5921 Cedar Parkway, Chevy Chase
(HPC Case # 35/13-10P)
Chevy Chase Village H.D.

SUBJECT: Historic Area Work Permit #546408; alterations to garage and breezeway

MONTGOMERY COUNTY HISTORIC PRESERVATION COMMISSION
STAFF REPORT

PROPOSAL: Alterations to garage and breezeway...

LENOX STREET

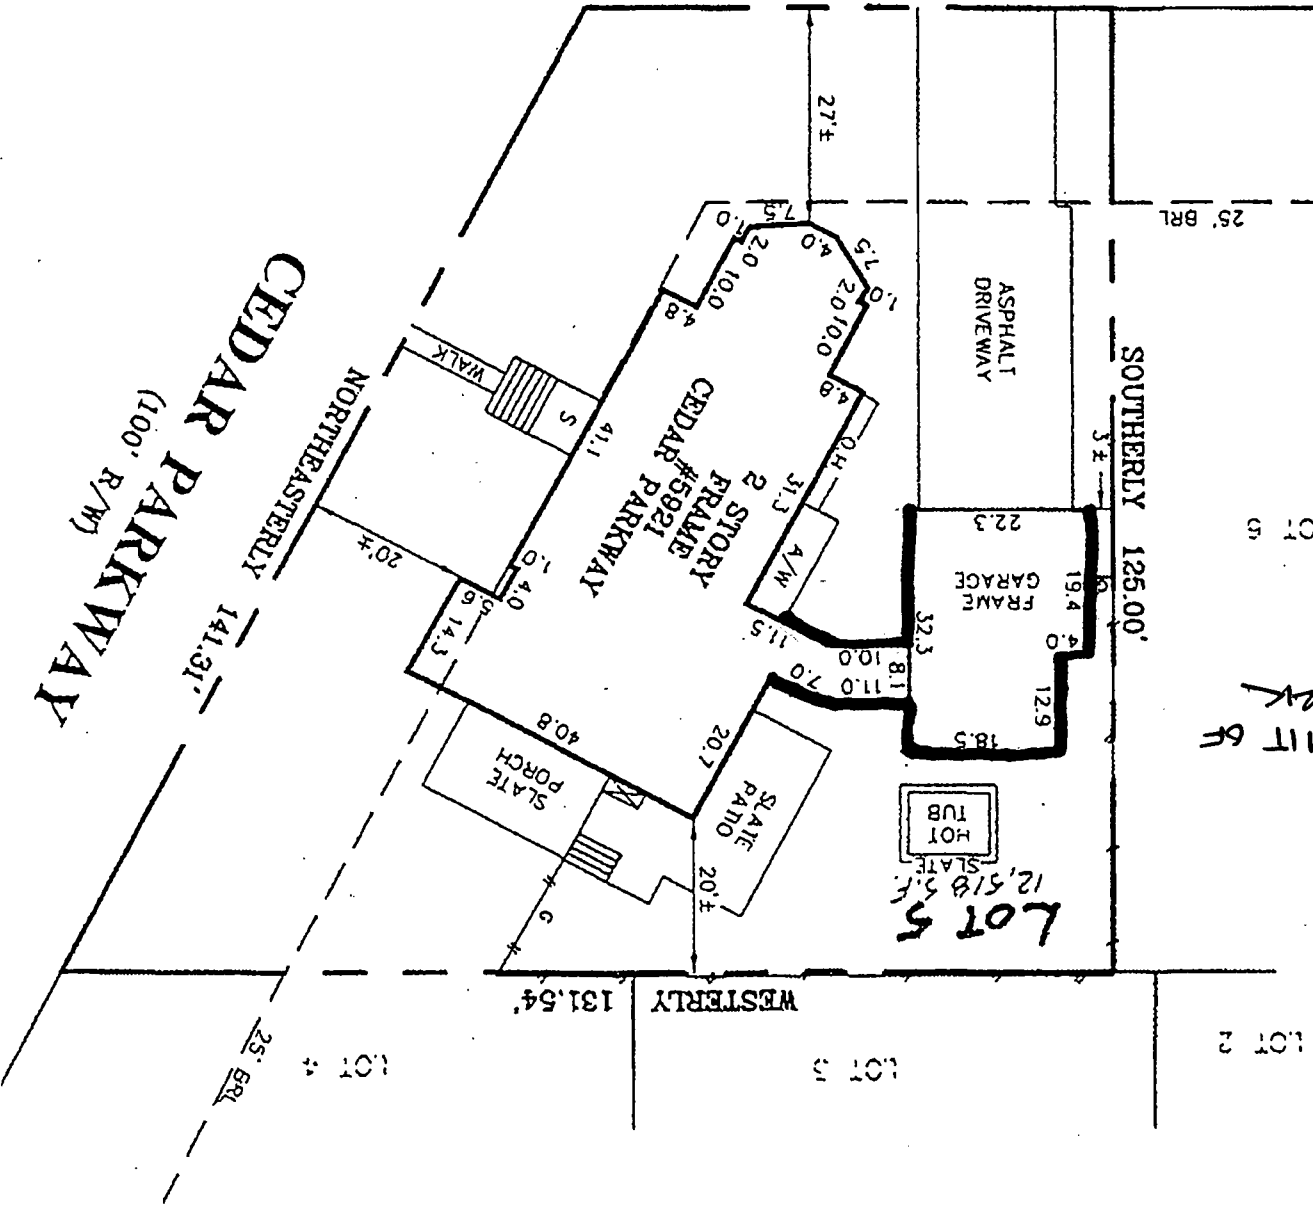
Staff supports the proposed siding removal and brick foundation wall installation project. The proposed work will have negligible impact on the streetscape of the historic district and does not substantially alter the exterior features of the historic resource.
